2CAN121206

SUBJECT: Clarification on Initial Flaw Size and Qualified Examination Area
Revised Request for Alternative ANO2-ISI-007
Code Case N-770-1 Baseline Examination
Arkansas Nuclear One, Unit 2
Docket No. 50-368
License No. NPF-6

Attachment to
2CAN121206
Revised Scan Profile

| | | TITLE: REACTOR COOLANT PUMP SUCTION DISSIMILAR METAL WELD | |

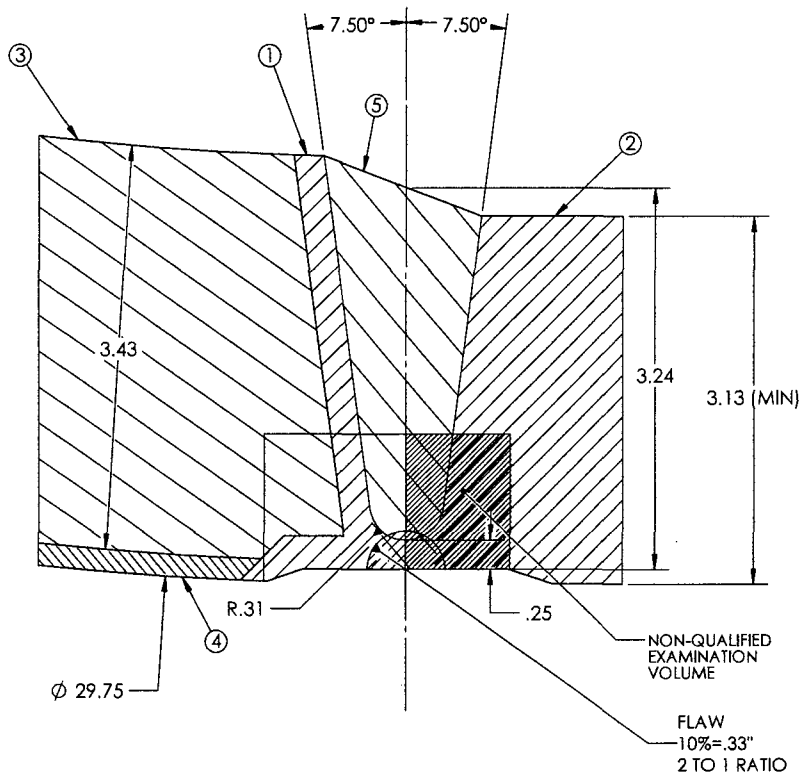
Both the Reactor Coolant Pump (RCP) suction and discharge DMW have similar weld preps at the cast austenitic stainless steel (CASS) safe-end and ferritic piping. The ferritic piping is buttered with an Alloy 82/182 filler metal. Westinghouse generic industry Primary Water Stress Corrosion Cracking (PWSCC) flaw analyses considered an axial flaw in the center of the DMW as illustrated in the attached RCP Suction DMW (weld 10-014) drawing for the following reasons.

The root of these welds require an inside diameter (ID) backgroove to sound base and weld metal with a subsequent Alloy 82/182 backfill weld out. This process will increase the residual stresses at the ID root. In addition, the weldment is diluted with the stainless steel (CASS) on the stainless steel (CASS) side. Therefore, if a PWSCC flaw were to initiate, it has the highest probability to occur in the centerline of the ID root weld. With an assumed flaw having a 2-to-1 aspect ratio and a 10% through wall initial flaw depth, the assumed flaw would essentially cover the width of the root of the DMW. This assumed flaw originating at the center of the DMW is larger than and bounds a flaw originating from the corner near the stainless steel (CASS) to DMW root. Whereas if a flaw were assumed to initiate near the stainless steel (CASS) to Alloy 82/182 weld interface, a corner type flaw would only grow in the direction of the susceptible material, resulting in a smaller flaw than the assumed centerline flaw. Additionally, the neighboring stainless steel weld has a beneficial effect on the DMW for PWSCC (compressive residual stress). The only other possible crack initiation site is near Alloy 82/182 to clad interface. The axial flaw will arrest as it radially intersects the carbon steel pipe. Crack propagation beyond the carbon steel ID from the clad would have been readily detected from the past examination. Therefore, the most conservative crack location is at the centerline of the weld root.

The favorable contours of the subject welds, combined with use of electronic skewing, demonstrate that the portions of the weld beyond the centerline were interrogated. It is therefore reasonable to conclude, in conjunction with the quantitative comparison above, that a conservatively positioned 10% through wall flaw at the inside diameter would have been detected. A weld profile drawing for the limiting weld (weld 10-014) is attached.
